VARIANCE REQUEST AND REPORT TO THE STORMWATER DRAINAGE MANUAL

1431 Community Park Drive, Columbus, Ohio
(CC-18536)

Bird+Bull, Inc.

MINIMAL IMPACT ALTERNATIVE SITE PLAN

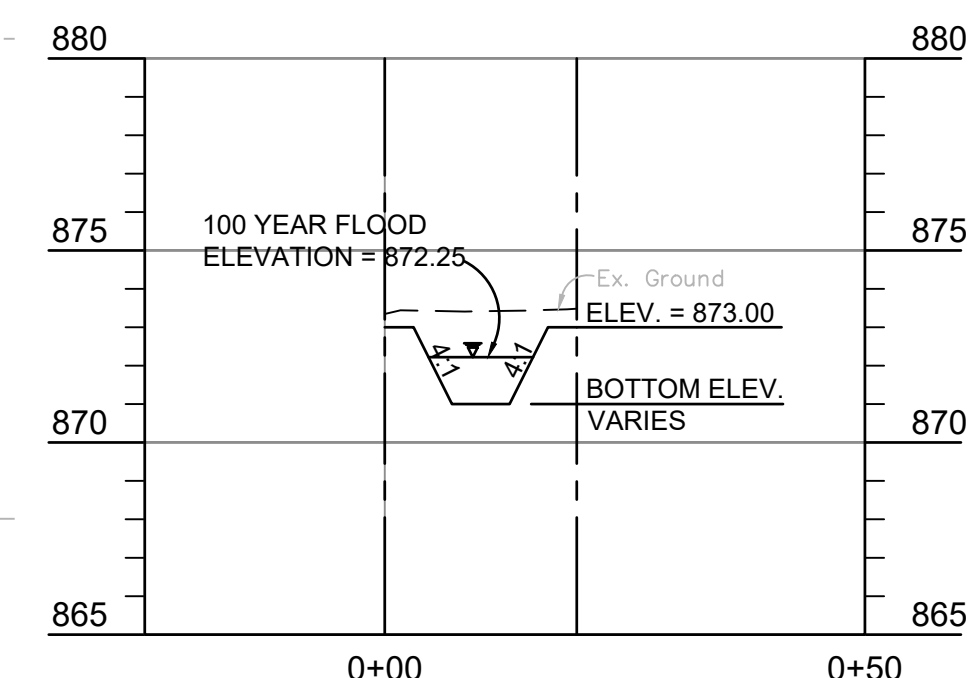
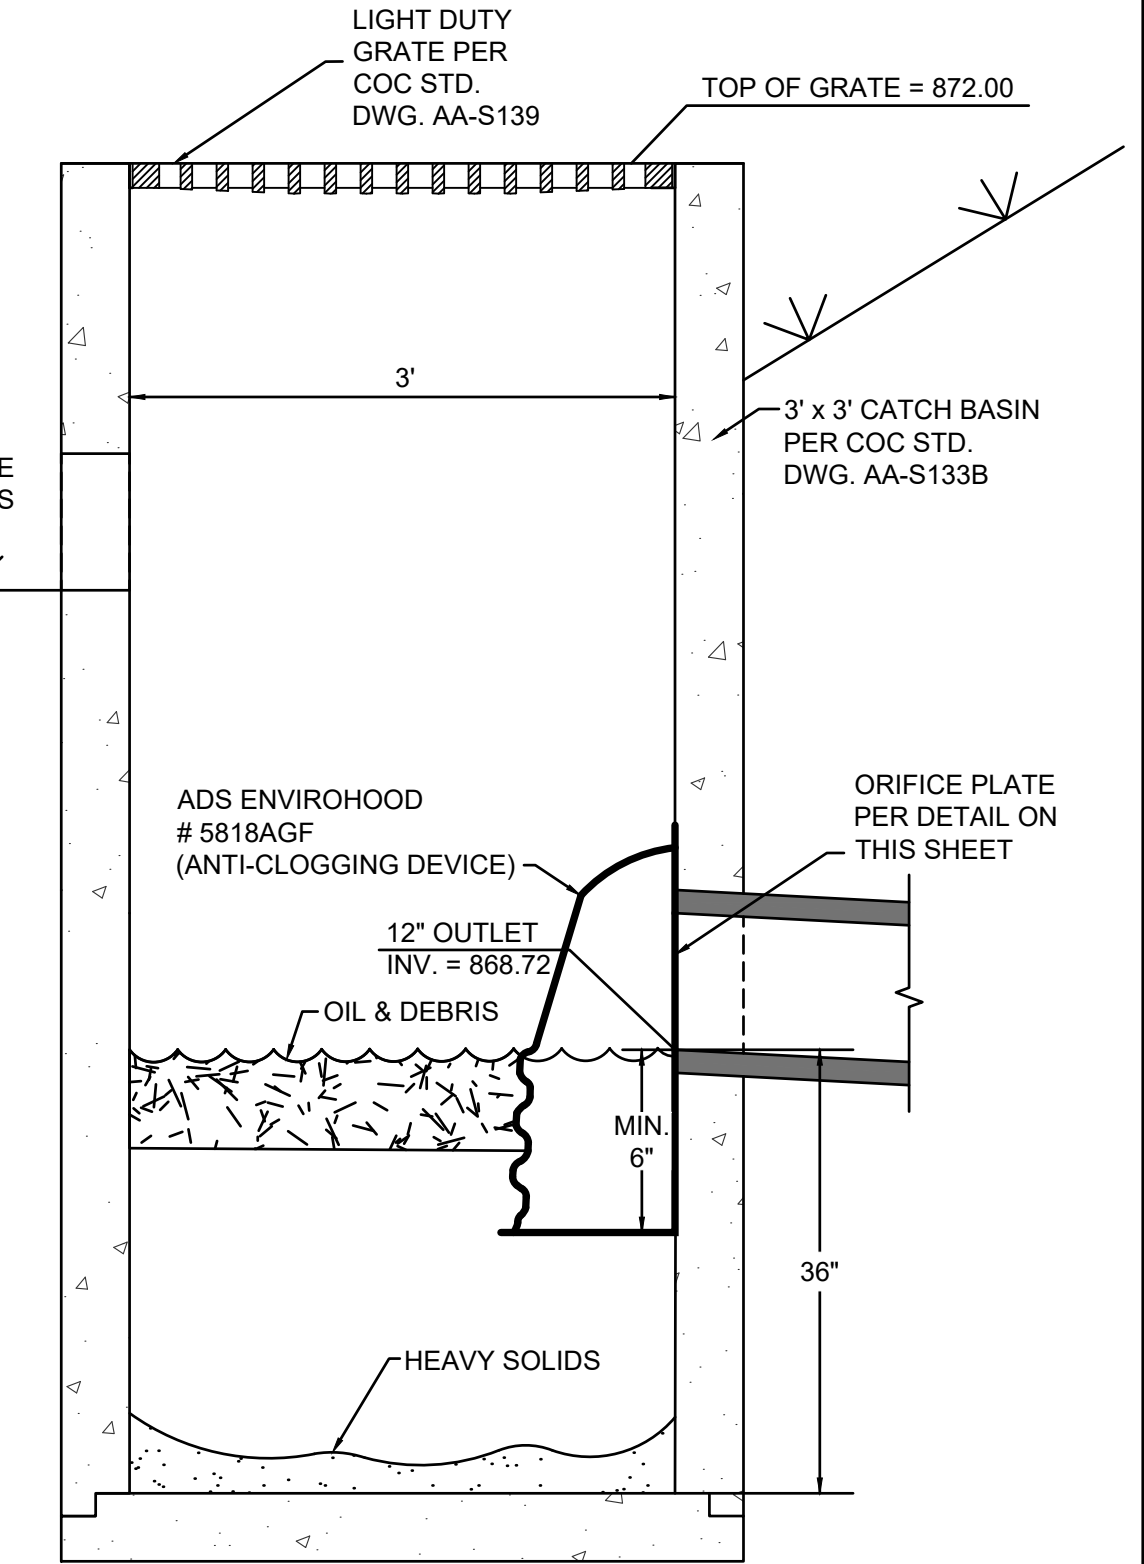
The pipe cover argument is not acceptable. There are many projects in the City with cover this shallow over the pipe. Typically, this issue could be solved by using traffic grade concrete sewer structures and pipe.

The pipe cover argument is not acceptable. There are many projects in the City with cover this shallow over the pipe. Typically, this issue could be solved by using traffic grade concrete sewer structures and pipe.

It appears the modified Minimal Impact alternative is feasible and would not require variance. Must clarify the hardships this alternative would place on the owner.

Response: Please see the revised plan.

Response: Please see the revised plan.

Response: This alternative would cost the owner considerably more than the Preferred Site Plan and would take up significantly more usable area of the property.

PREFERRED ALTERNATIVE SITE PLAN

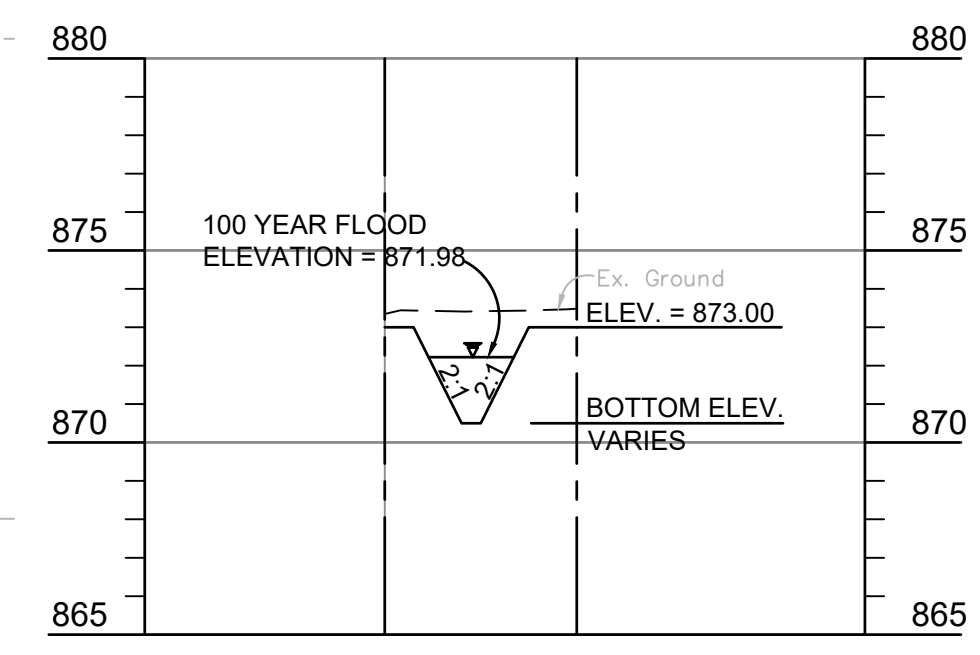
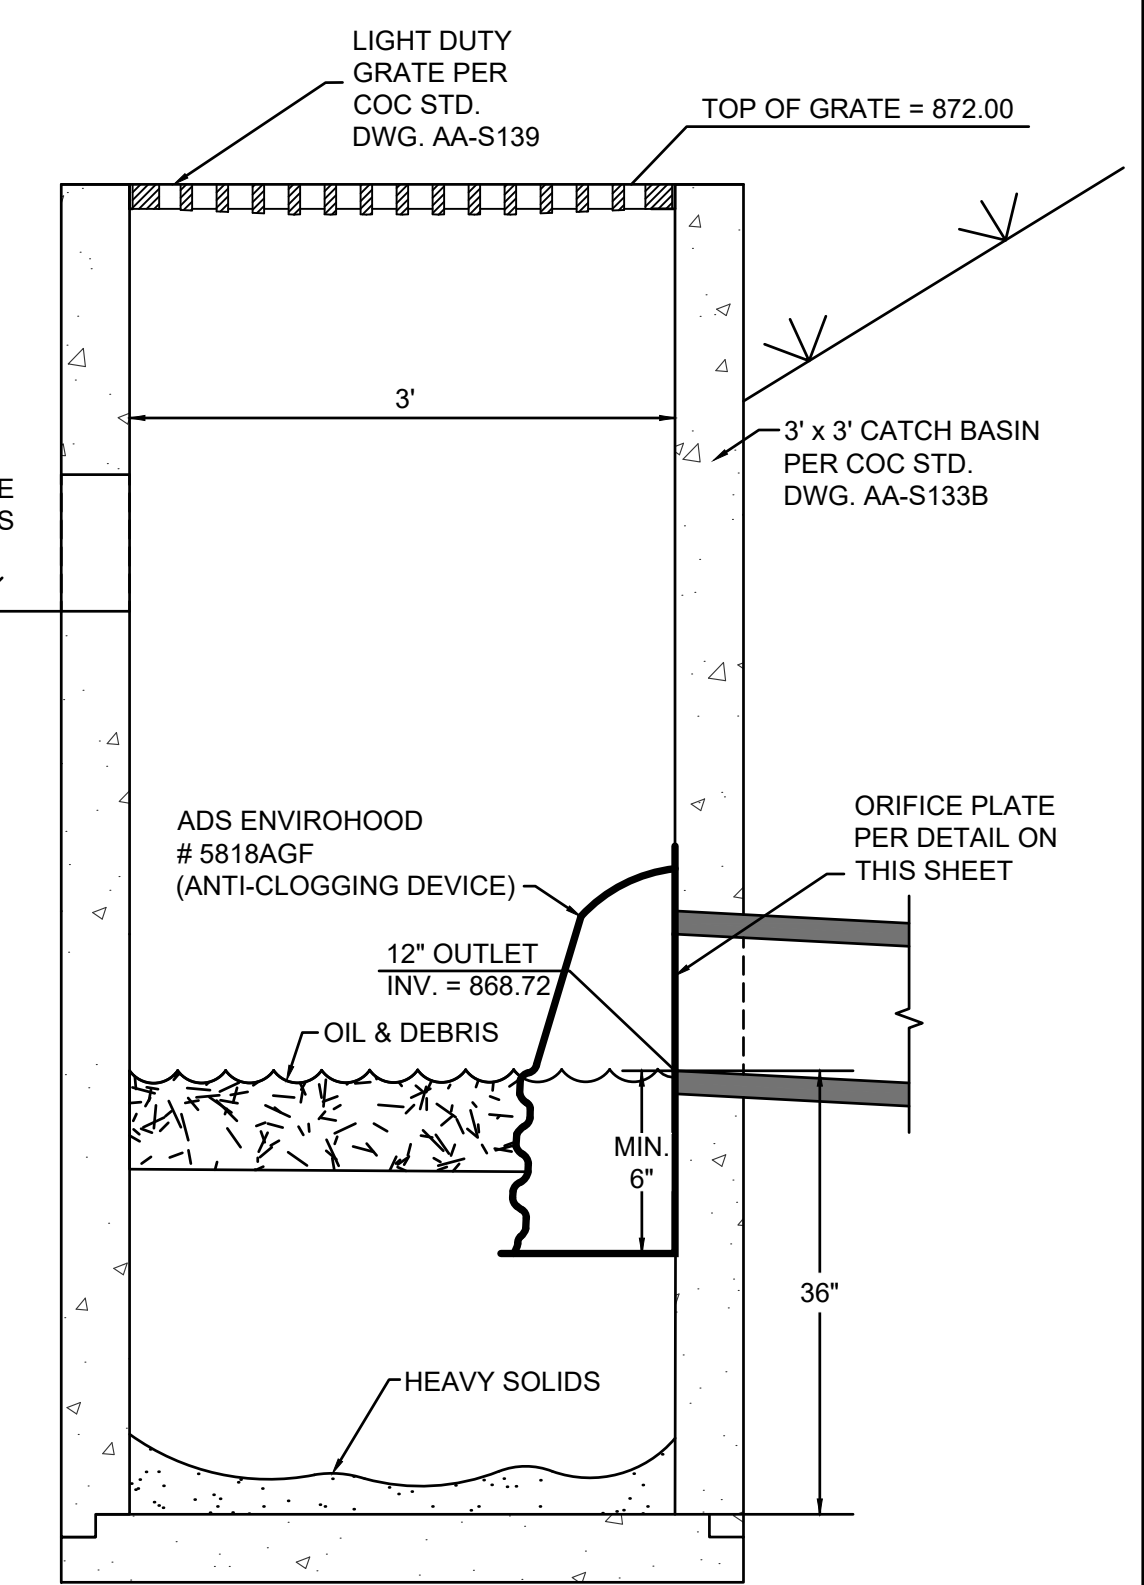
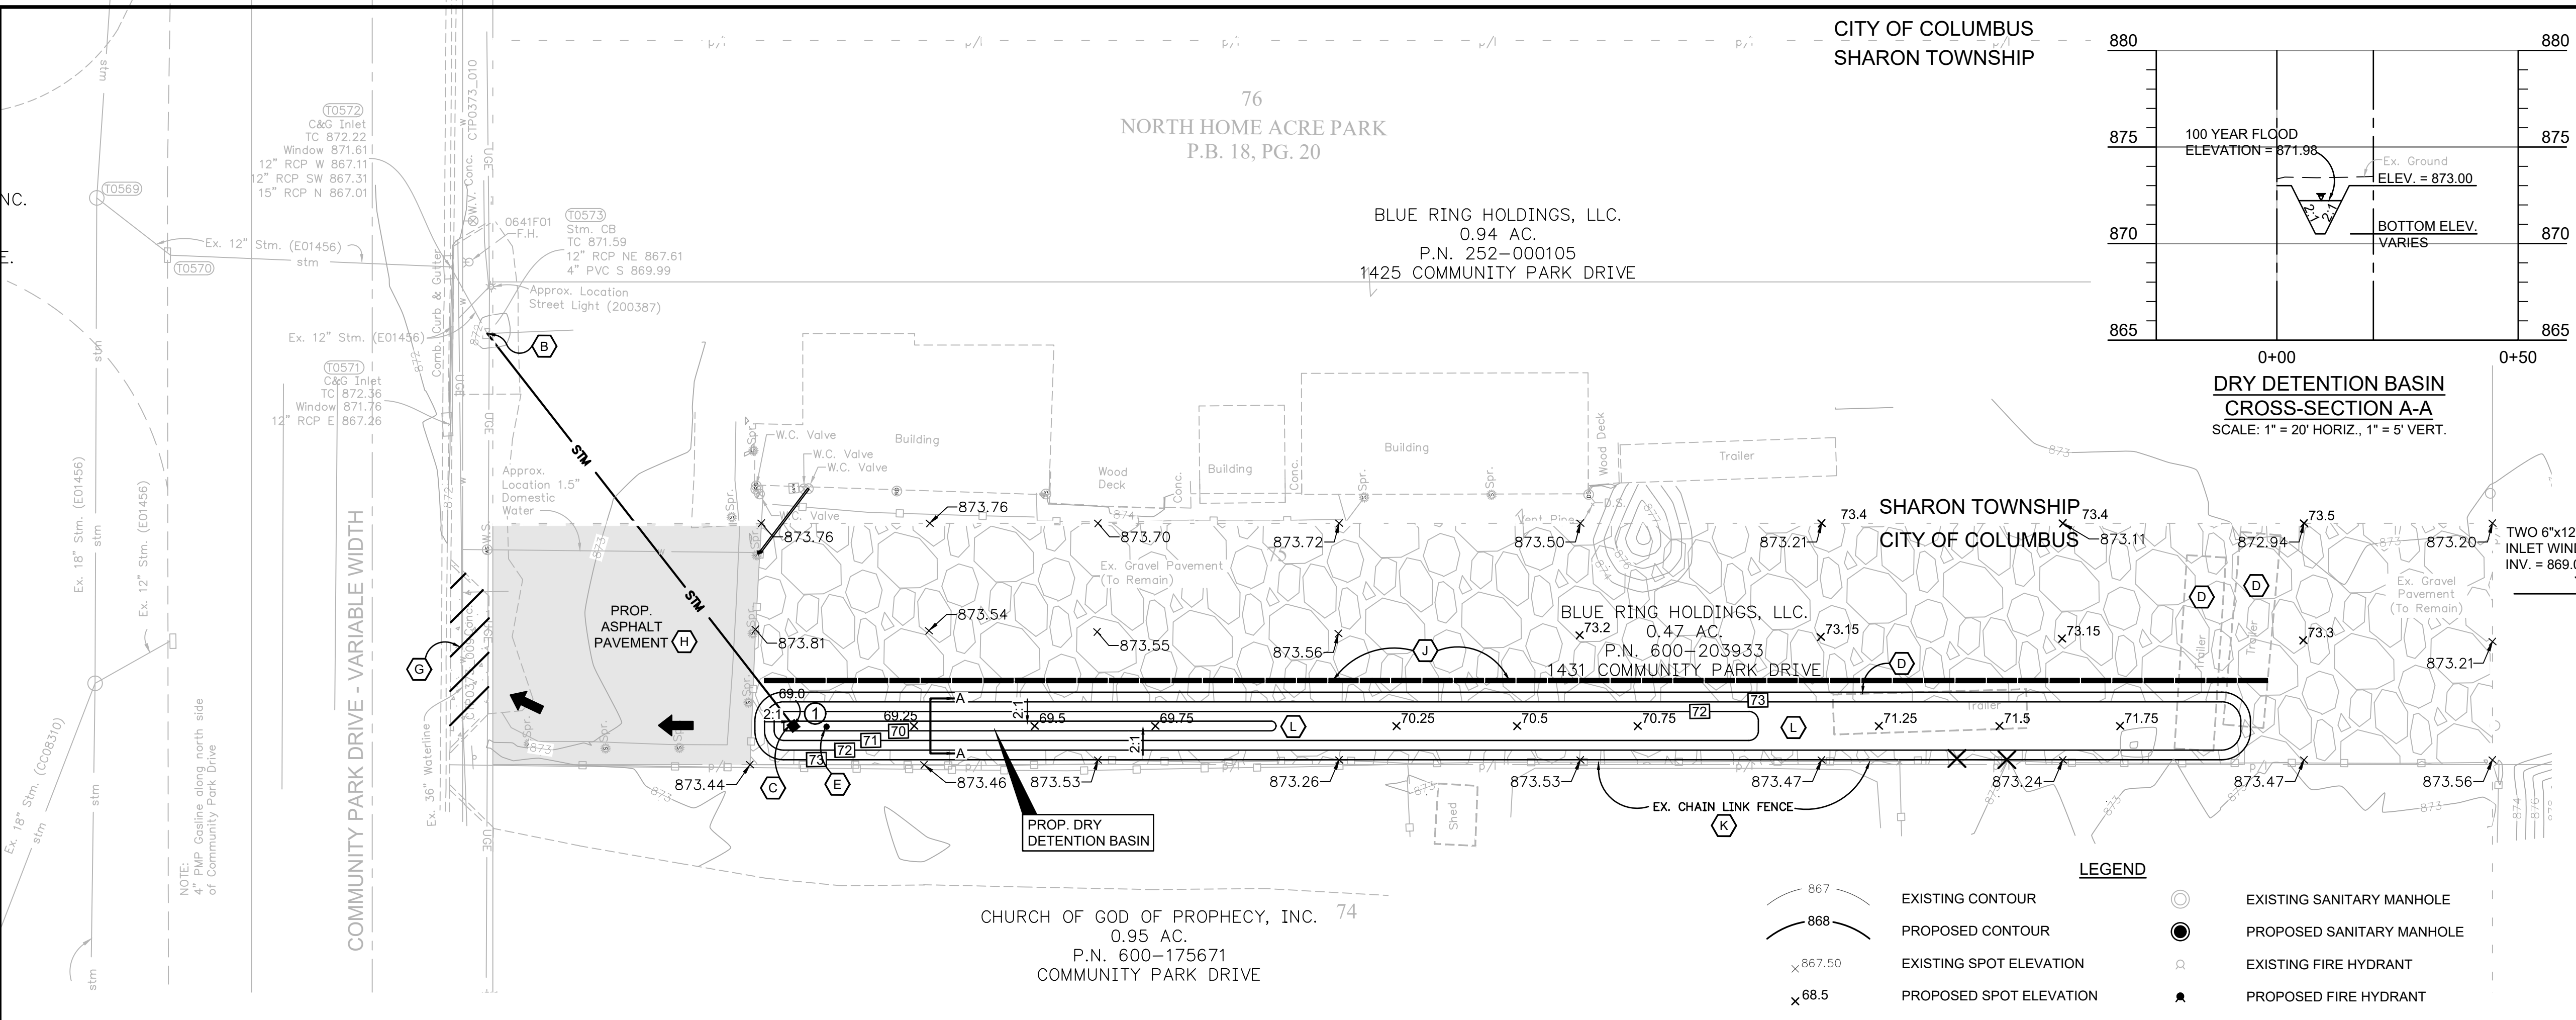
A flatter than required basin floor would at the very least require an underdrain system to prevent ponding and resulting health/sanitary issues.

Required: This response is not sufficient. How will ponding be prevented?

Proposed hand cleaning of the preferred alternative basin would not work when ownership of the land is transferred. We always must consider the sustainability of system maintenance for all future owners that will be responsible for the system in the future.

Required: Our concern is future owners will not have the staff for the hand labor necessary to maintain the proposed basin. Please explain how you are proposing to address.

The proposed vegetation for the steeper than 4:1 side slopes will likely not be functional within 10 years.

Required: Our concern is the erosion that can occur and the high maintenance that will be required to maintain. Please explain how you are proposing to address.

The detention basin layout proposed under the Preferred Alternative will be challenging for workers to enter to maintain due to likely muddy bottom conditions.

Required: This is still a concern for future owners. Please explain how you are proposing to address.

To maintain the basin the landscaper at the site will maintain plantings that can take the 2:1 slope and periodic submerging. Not addressed in the re-submittal

Required: Red fescue is not tolerant of water submergence. How will invasive creeping of Vinca minor and ajuga be controlled?

Previous reply: What we are proposing essentially is a vegetated swale and because of that an underdrain is not warranted on such a small area.

Response: See revised seeding mix and explanation above. If the performance as proposed is unacceptable, we will install a 4" perforated underdrain in the bottom of the basin and reseed with straw blankets.

Previous reply: We will record a document encumbering the present and future owners of the property of their responsibility to maintain the drainage system as per the approved CC plan.

Response: Any potential future purchaser should review the documents of record and will see the commitment and the reference to the CC plans. With ownership that purchaser will be responsible to stay in compliance with the required maintenance or be subject to the penalties associated with non-compliance regardless whether or not it is inconvenient. We are unaware of a requirement that an encumbrance on Title of a property for storm water improvements and the maintenance of those improvements but on this property we have agreed to provide that notice to any purchaser. Ultimately, if a purchaser makes the decision that the maintenance of the storm water improvements is too large of a burden then that purchaser has the option to submit for approval an alternative storm water plan and then construct the new improvements which may have less maintenance than what is proposed. We would be very surprised if that occurred as with only a minimal amount of training any competent lawn maintenance contractor should be able to comply with the maintenance.

Previous reply: I am not sure why you believe that but if that occurs new vegetation can be planted.

Response: The proposed seeding, as depicted above, is a very durable deep rooted grass which should preclude any significant erosion. If it should fail it can be reseeded and covered with straw blankets to protect the slopes until such time that it is re-established.

Previous reply: The present staff and/or contractors work in muddy conditions often so that is not a problem.

Response: Please see the explanation above that deals with the alternative available to future owners.

Previous reply: We identified the specific planting in the Variance Request

Response: We engaged with a knowledgeable expert to assist us in the selection of a grass that will survive periodic short term submergence that is deep rooted and commonly used for ditch seeding.
